Norfolk Vanguard Offshore Wind Farm

Onshore Ecology Clarification Notes - Position Statement

Document Reference: ExA; ISH4; 10.D6.9

Date: 05 April 2019

Figure 1: Conceptual Model

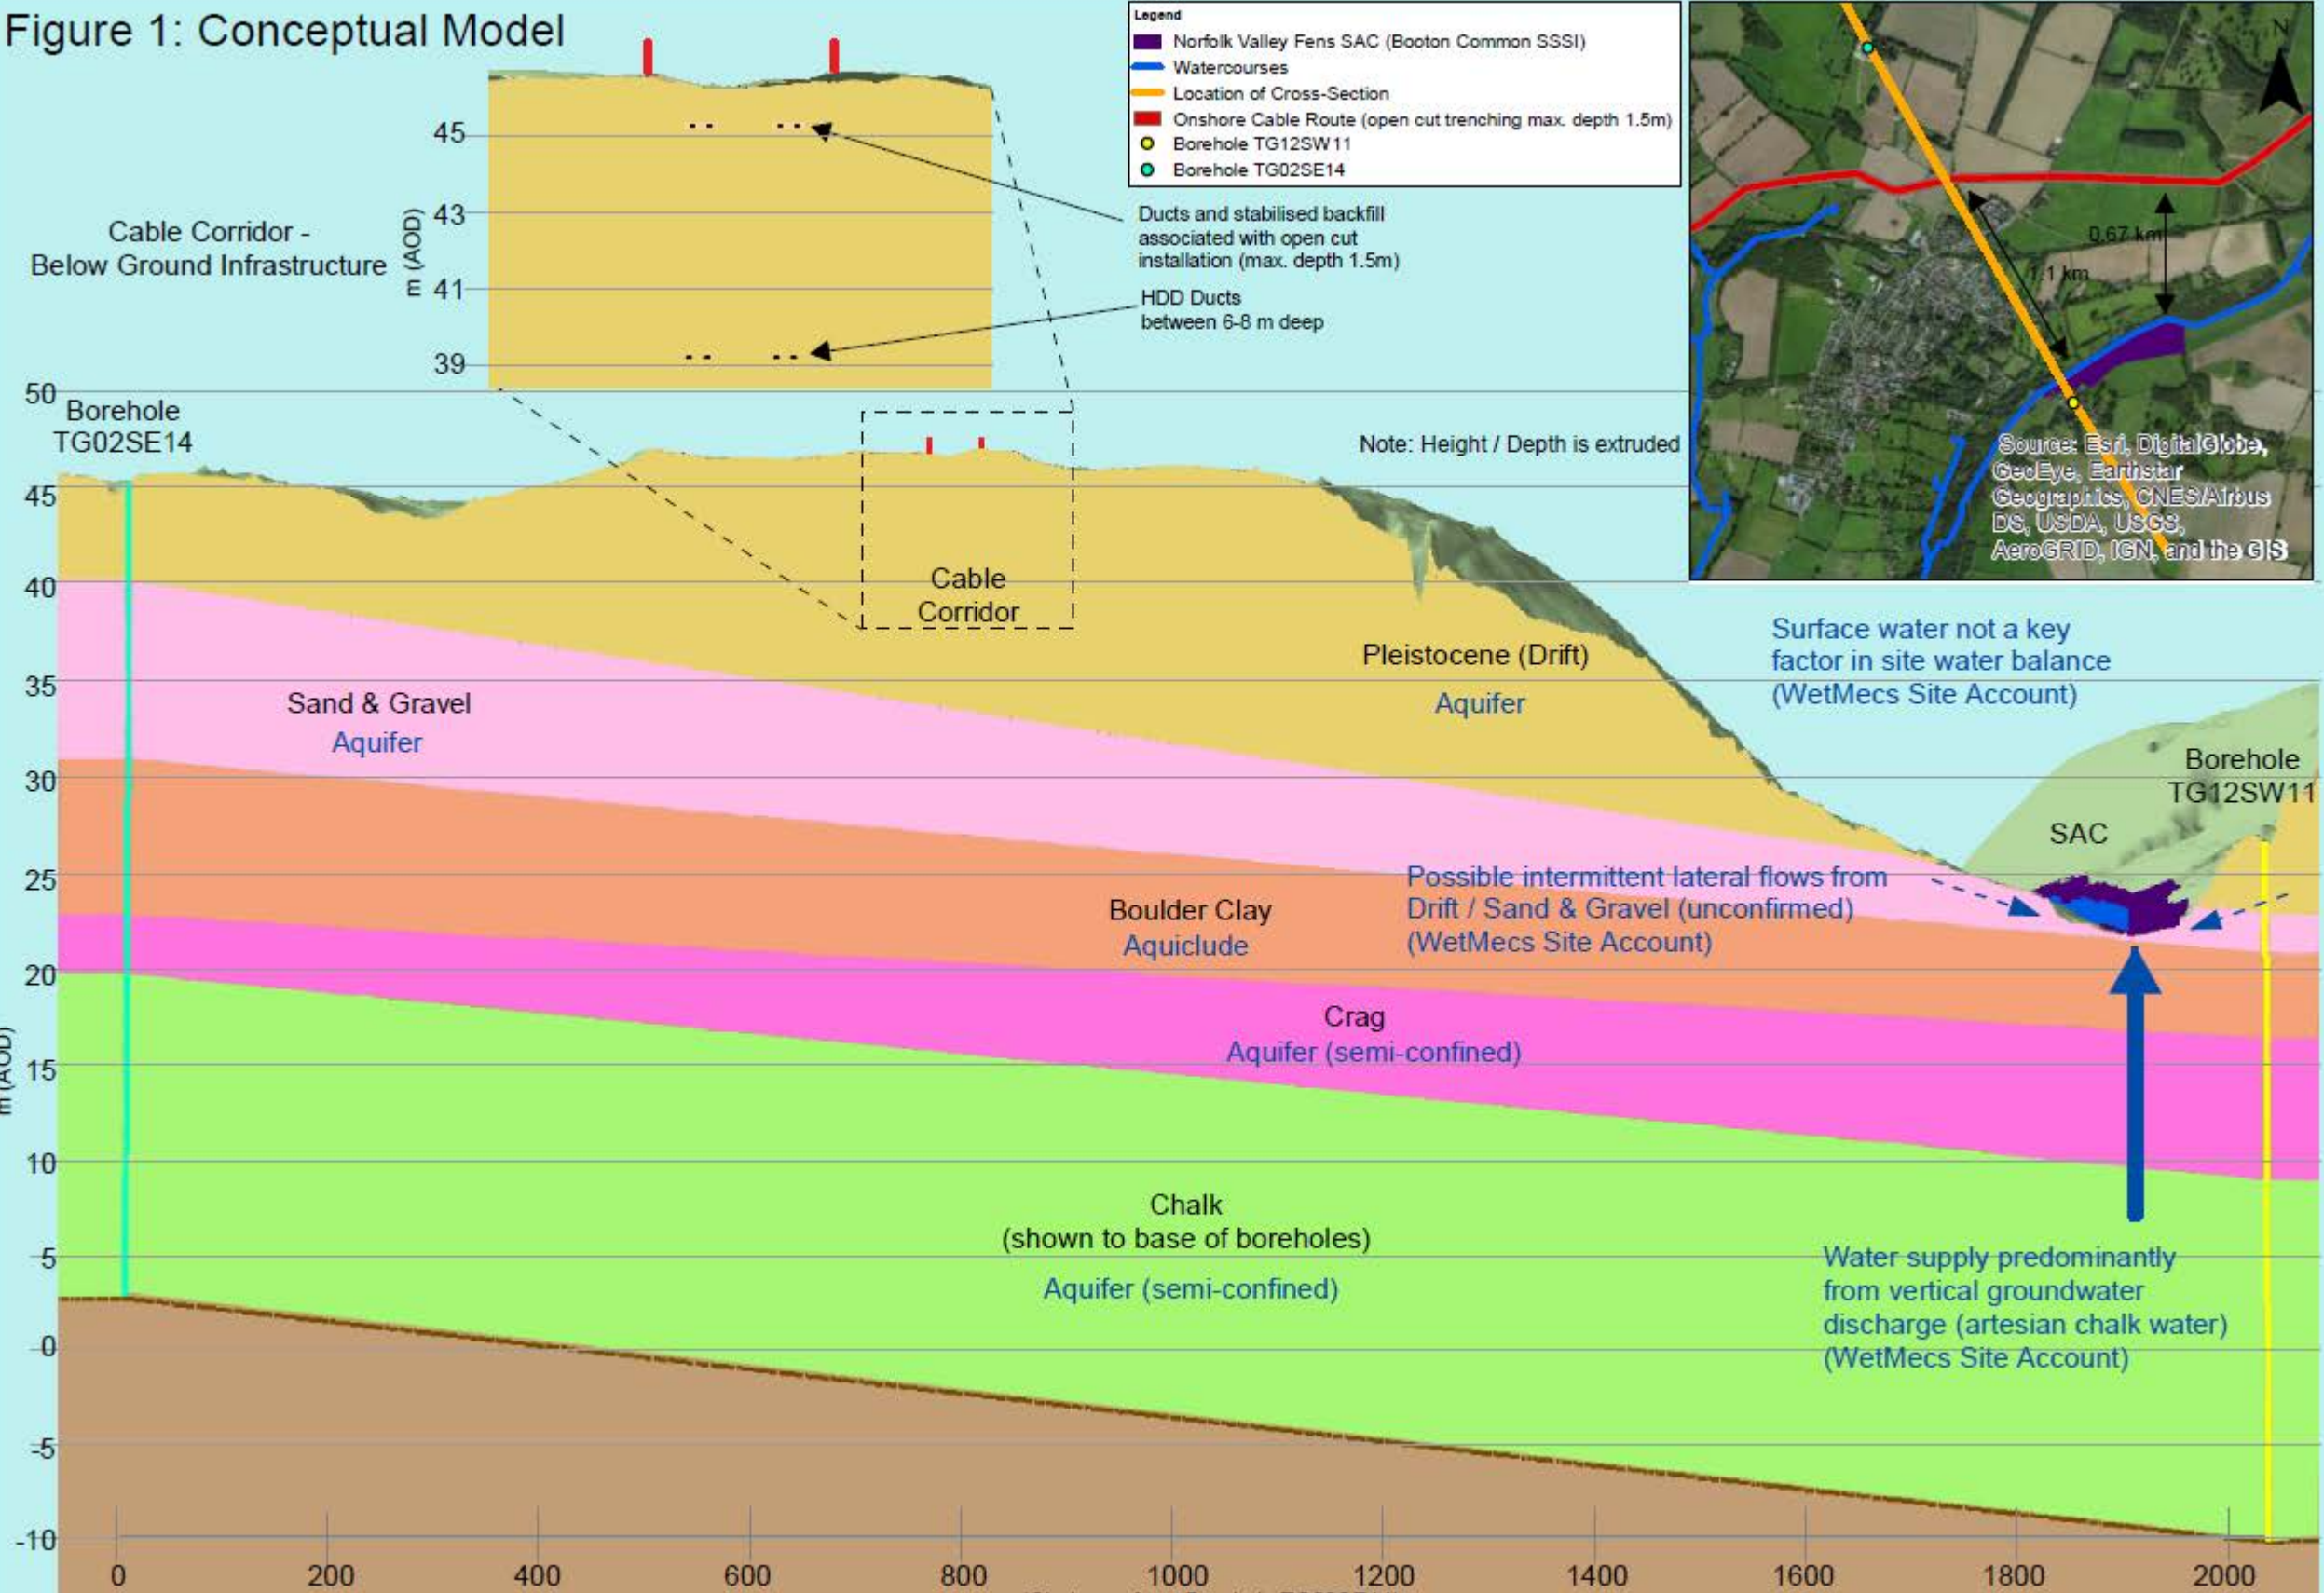
The updated Clarification Note dated 25 February 2019 provides sufficient detail regarding potential hydrological impacts on the sites where Natural England are particularly concerned. The updated Clarification Note now considers the EA's WETMEC data showing the water supply mechanism for all the component sites and provides a conceptual model to consider the risks of ground water supply to the sites from the development of the cable route. Natural England is happy that this is in line with the EA conceptual model.

Figure 1 illustrates that the cable route will not extend beneath the diamicton (boulder clay) layer. This is lower permeability material than the overlying sand and gravel of the glaciofluvial deposits (where present) and the underlying Chalk.

Figure 1 – location of trenchless crossings in proximity to the River Wensum and Penny Spot Beck

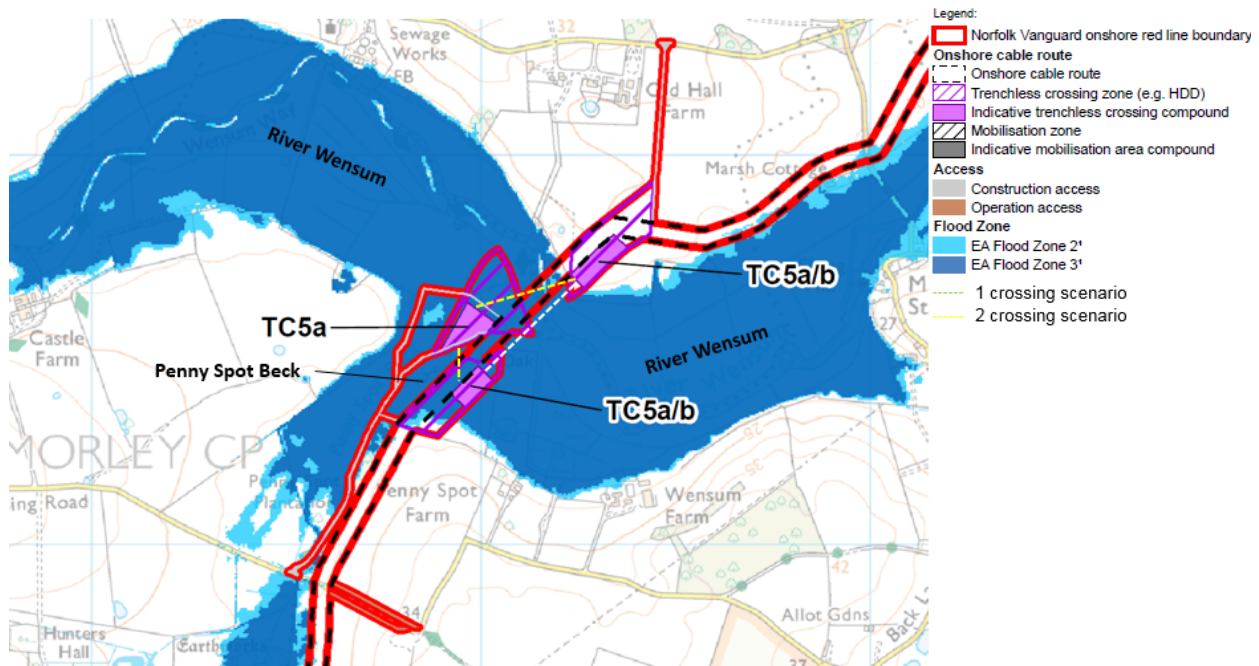
should be undertaken sensitively: deep turf stripping and reinstatement is more appropriate than natural regeneration or reseeded. We would be happy to agree a restoration plan when more information is known.'

However, Natural England notes that if the third compound is chosen it is still not known what the temporary new construction accesses will be formed of (e.g. protective matting (geotextile), temporary metal road or permeable gravel aggregate). Norfolk Vanguard Ltd. has committed to providing a detailed scheme and programme which will include site specific water course crossing, with consultation with Natural England. Natural England would expect further detail to be provided as to the location of temporary access (this is not illustrated In Figure 1 in the Clarification Note), design, materials, and post construction reinstatement. Natural England looks forward to receiving and commenting on the site specific crossing plan.

As a worst-case, a topsoil strip may still be required to establish the trenchless crossing compounds. This will be determined pre-construction following further site investigation and will be confirmed during detailed design. The three identified trenchless crossing compounds associated with the River Wensum crossing, shown on Figure 1, comprise:
